**Applicant/Project Name:** Restaurant Row Specific Plan

**Project Number:** SP22-0004

**Re: Reply to Responses to Comments to Initial Study/Mitigated Negative Declaration for the Restaurant Row Project, Project No. SP22-0004, Environmental Document No. ND23-011, dated August 2023**

**Reply to Comments 05-9, 05-10, 05-11, and 05-12**

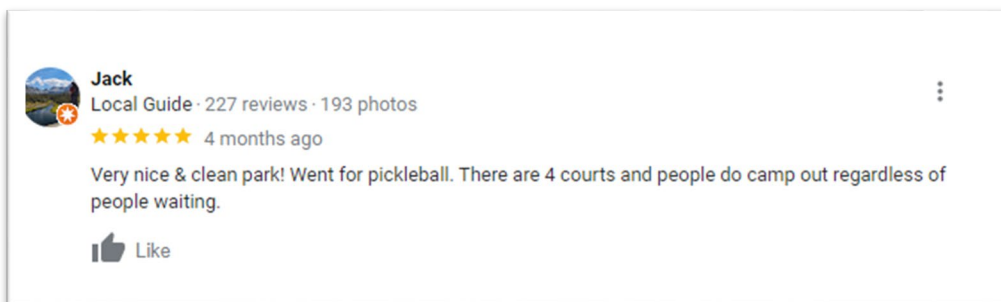
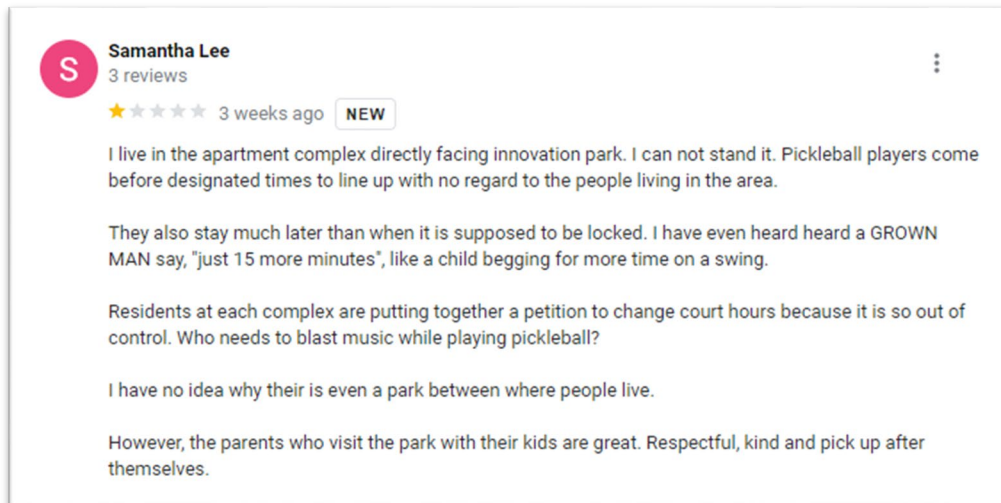
The City states that at its comparable Innovation Park, 30 people were observed at the four pickleball courts on a Saturday morning, on an undisclosed date. The comparison is not applicable, as Innovation Park does not have dedicated bleachers for players in waiting, and requires street parking that is subject to a two-hour limit. Even with those limitations, the pickleball uses at Innovation Park have drawn criticism from the public based upon noise, crowding (i.e., camping), and failure to follow hours of operation:
